HISTORIC AND DESIGN REVIEW COMMISSION

HDRC CASE NO: 2022-159
ADDRESS: 222 WICKES
LEGAL DESCRIPTION: NCB 942 BLK 1 LOT W 67.3 FT OF 6 AT 222 WICKES
ZONING: RM-4,H
CITY COUNCIL DIST.: 1
DISTRICT: King William Historic District
APPLICANT: Jason Moran/Jason Moran Collaborative Ventures
OWNER: Genaro Rendon
TYPE OF WORK: Partial demolition, construction of a 2-story rear addition, exterior modifications
APPLICATION RECEIVED: February 25, 2022
60-DAY REVIEW: Not applicable due to City Council Emergency Orders
CASE MANAGER: Stephanie Phillips
REQUEST:

1. Demolish a non-original 2-story rear addition.
2. Construct a new 2-story rear addition.

FLOOR PLANS

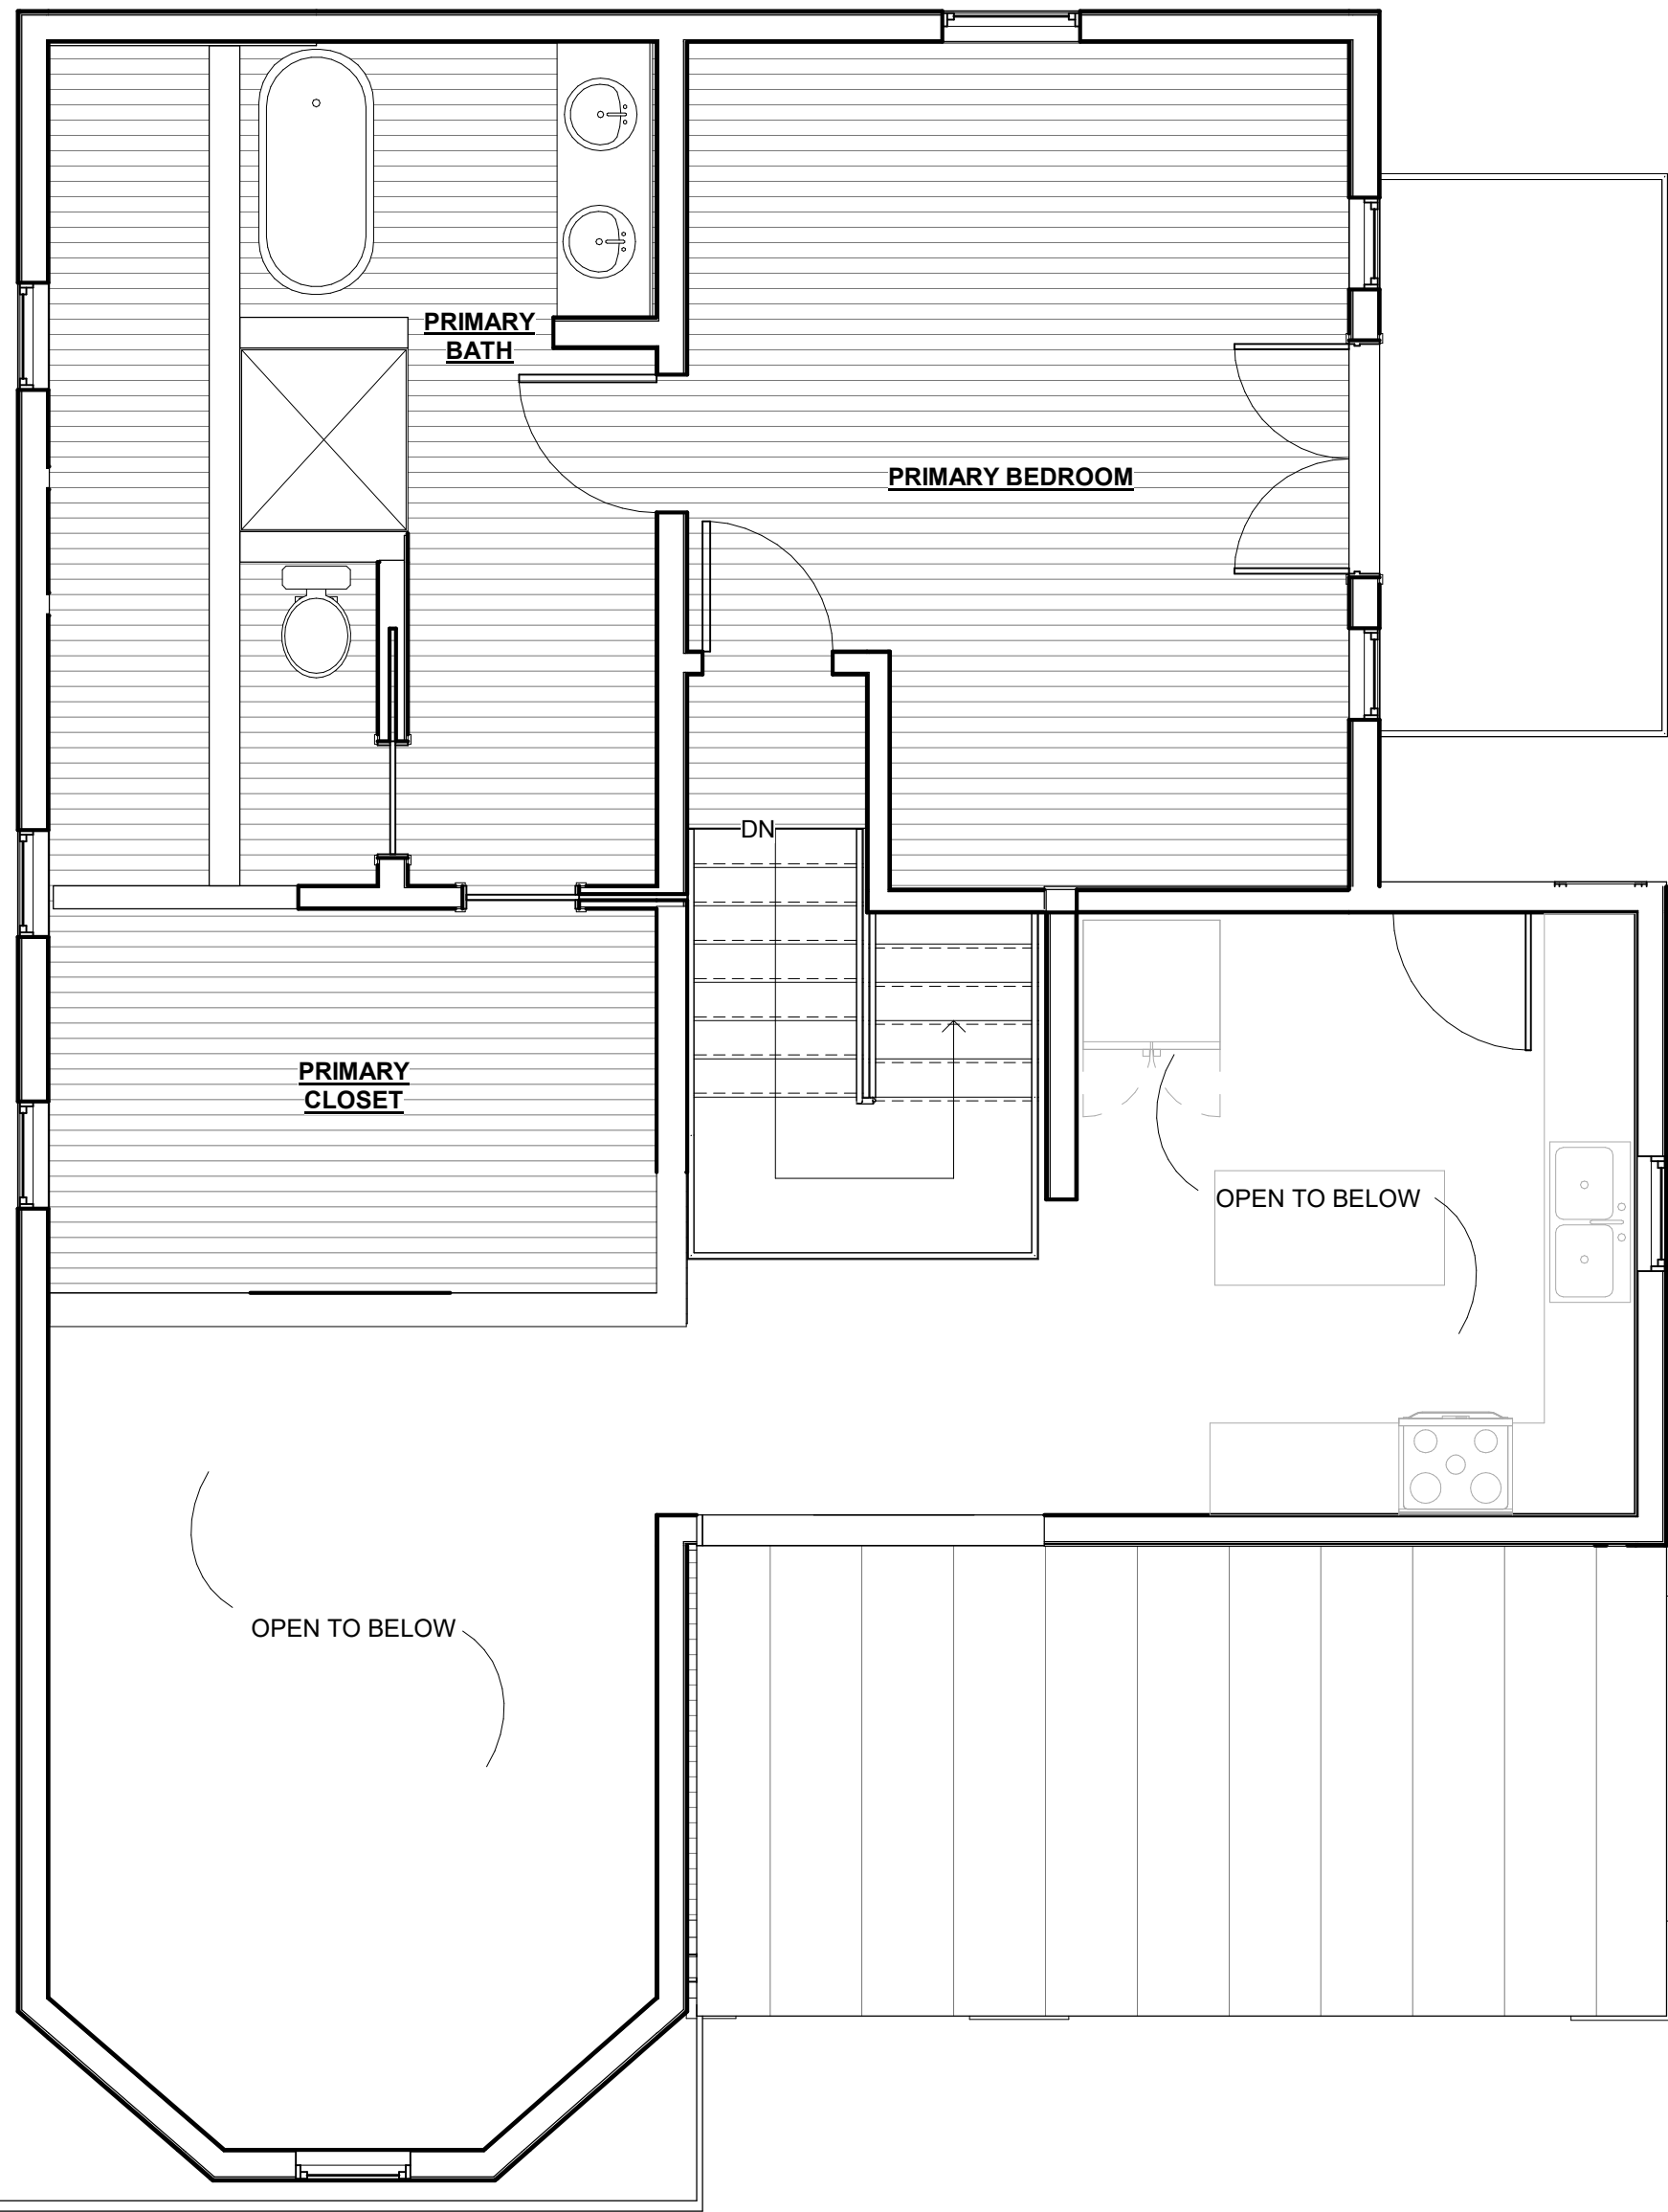
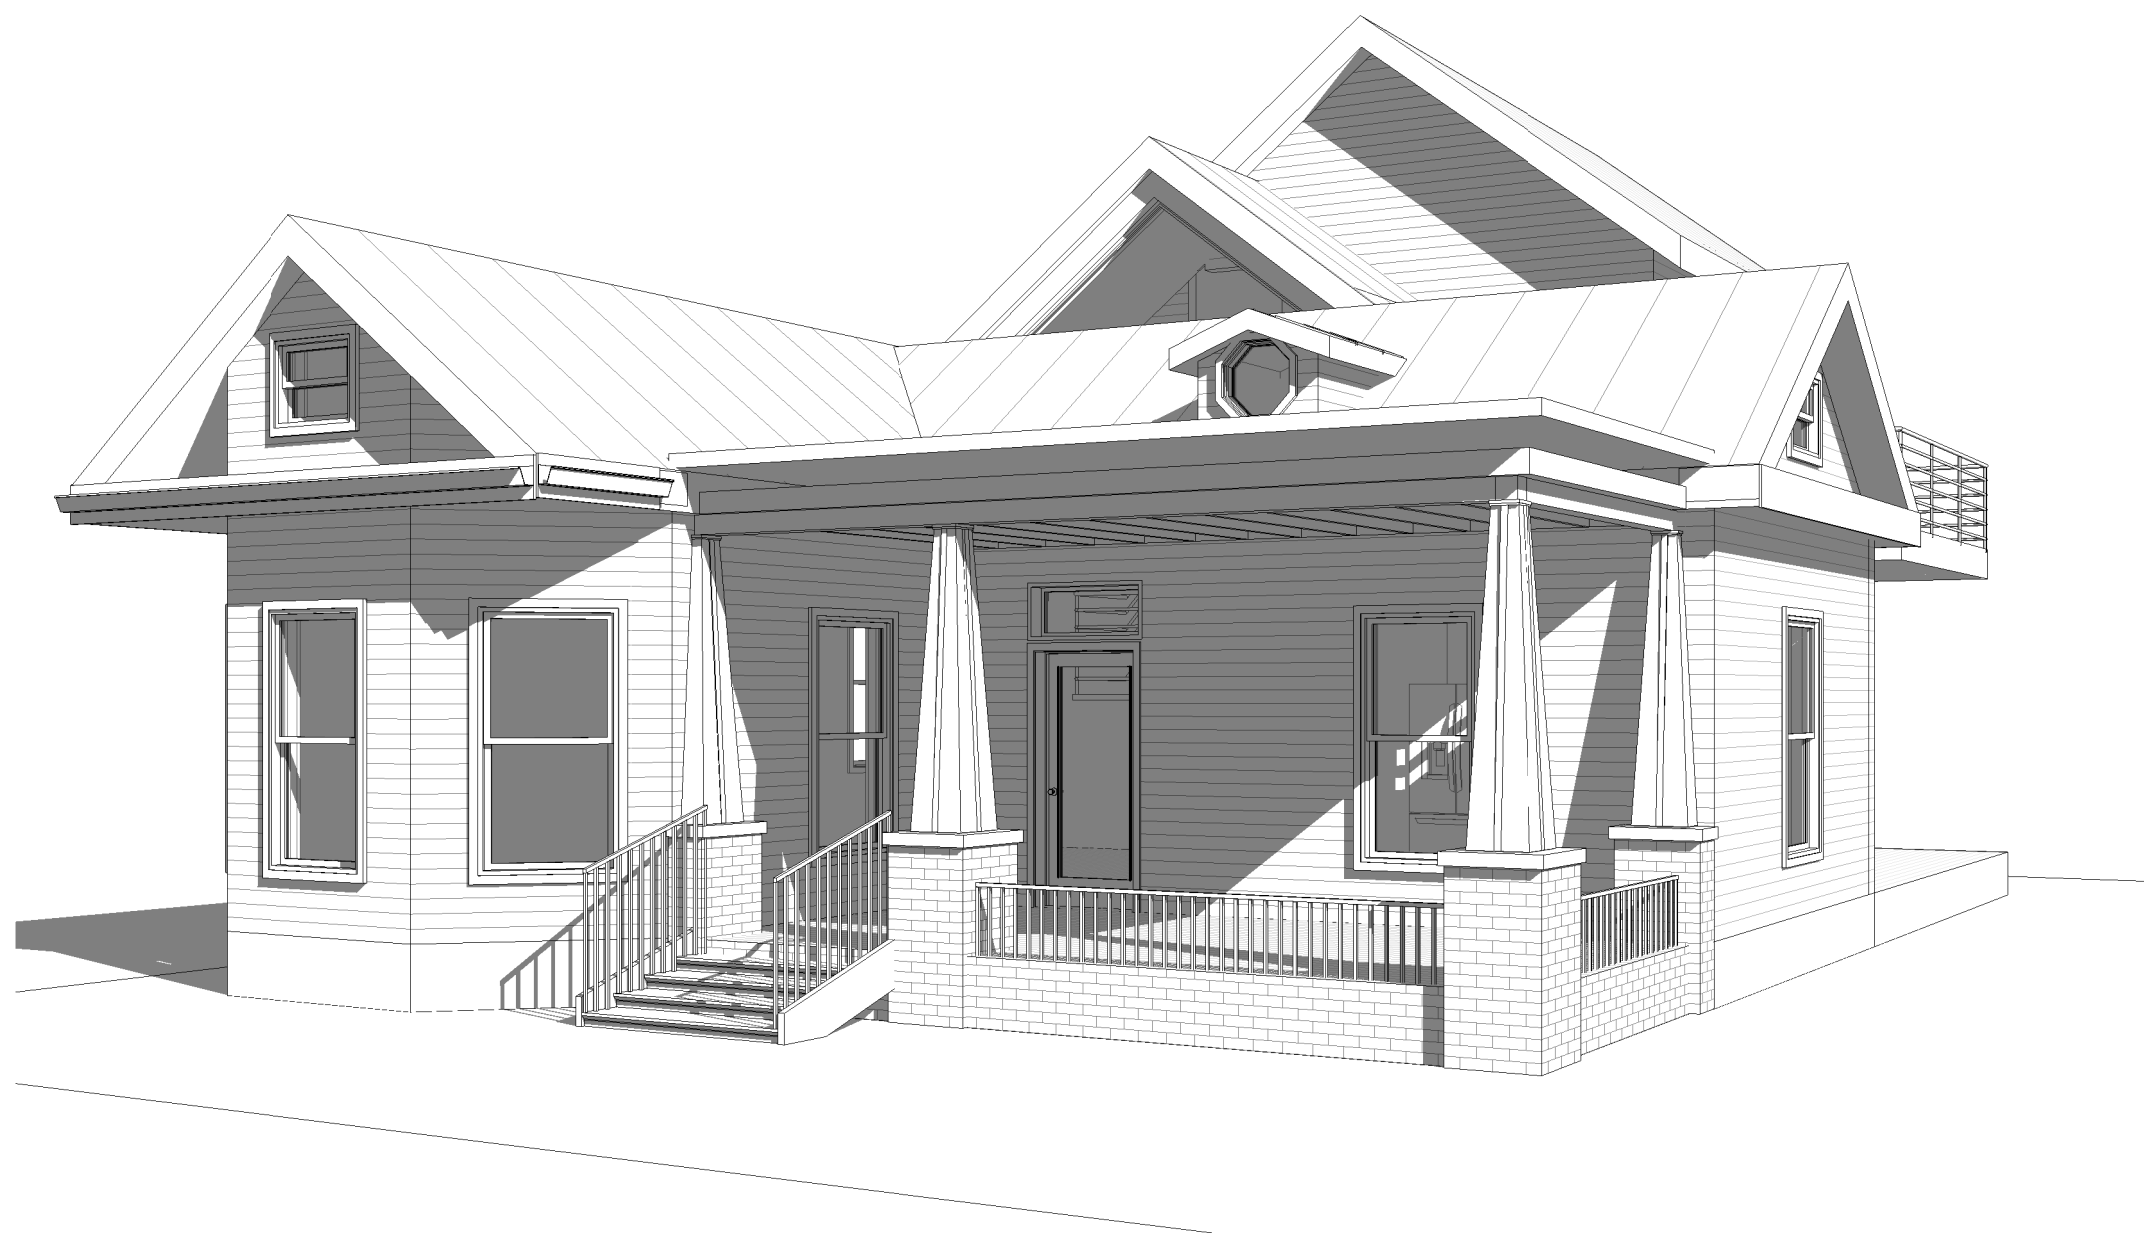
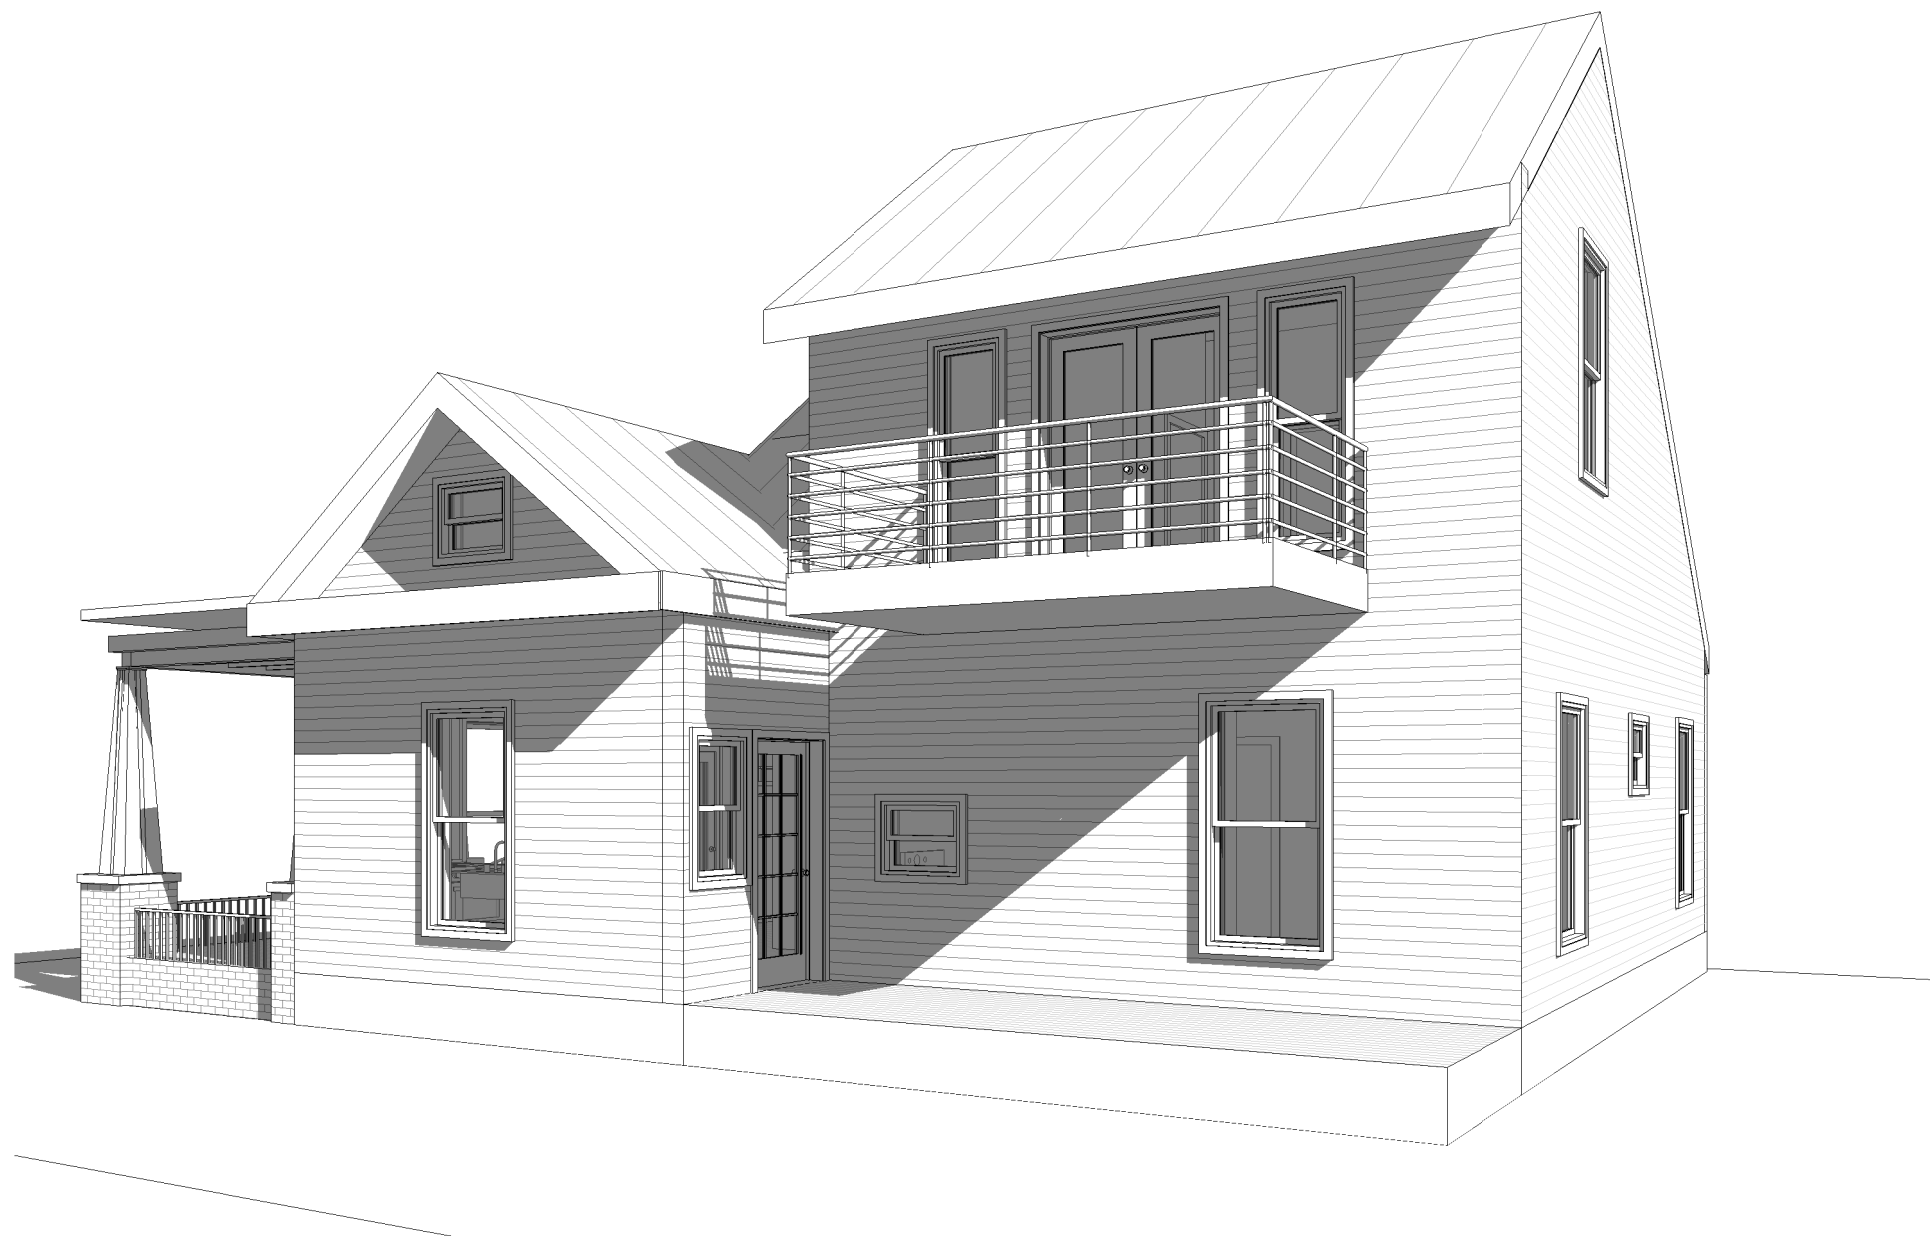
- d. FOOTPRINT – The applicant as proposed to construct a new 2-story addition to the primary structure in the general location of the existing rear addition to be removed. Per the submitted calculations and drawings, the new addition will add approximately 200 square feet in footprint. The existing primary structure's square footage is approximately 1,116 square feet, including the footprint of the existing 1-story addition, and the new footprint will measure approximately 1,320 square feet. The Historic Design Guidelines for Additions stipulate that new additions should not double the footprint of the primary structure in plan. Staff finds that the proposal generally meets this guideline.

- f. SCALE – Though the overall height of the addition is not indicated on the submitted drawings, the addition will be two stories and appears to be a height of 26-28 feet at the tallest ridge. The addition includes a taller front gable configuration with a subordinate gable that sits partially atop the existing primary historic structure. The current rear addition to be removed is separate from the primary structure's mass and does not sit atop the primary structure's roofline. The Historic Design Guidelines state that new additions should be subordinate to the primary structure in height and should utilize a similar roof pitch, form, overhang, and orientation as the historic structure for additions. Staff finds that the height, scale, and roof form of the addition overwhelms the primary structure due to its encroachment on the historic structure with a lack of clear transition. Staff does not find the scale consistent with the Guidelines as currently proposed.

- i. **ROOF FORM** – As noted in finding f, the proposed 2-story rear addition will utilize a primary front gable roof form with a subordinate gable partially atop the existing structure. The roofline of the west elevation features a steep slope that appears to align with the front gable pitch of the historic structure. According to the Guidelines, roof forms on additions should respond to the roof form of the primary structure and predominant roof forms used historically in the district. Staff finds that the height, scale, and roof form of the addition overwhelms the primary structure due to its encroachment on the historic structure with a lack of clear transition. Staff does not find the scale consistent with the Guidelines as currently proposed.

- j. **TRANSITION** – As noted in findings f and i, the Guidelines encourage a clear transition between primary structures and additions, especially if the scale, massing, or height of the addition is larger than the existing structure. Staff finds that the applicant should propose a connector element, a stepped roofline that transitions from 1 to 2 stories, or another method of transition that minimizes the addition's visual and structural impact on the primary structure.

- ii. That the addition be set back further from the primary structure and incorporate a clear transition from the primary structure, such as a connector element, a stepped roofline that transitions from 1 to 2 stories, or another method of transition that minimizes the addition's visual and structural impact as noted in findings f, i, and j. A roof plan should be submitted that clearly indicates how the new addition will affect the historic structure's existing roofline.

- iii. That the proposed addition's roofline be modified to reduce the visual impact on the primary structure as noted in findings f, i, and j.
- iv. That the applicant submits window specifications to staff for review and approval. Windows should be fully wood or aluminum clad wood and feature an inset of two (2) inches within facades and should feature profiles that are found historically within the immediate vicinity. White color is not allowed, and color selection should be presented to staff. Meeting rails must be no taller than 1.25" and stiles no wider than 2.25". There should be a minimum of two inches in depth between the front face of the window trim and the front face of the top window sash. This must be accomplished by recessing the window sufficiently within the opening or with the installation of additional window trim to add thickness. Window trim must feature traditional dimensions and an architecturally appropriate sill detail. Window track components must be painted to match the window trim or be concealed by a wood window screen set within the opening.
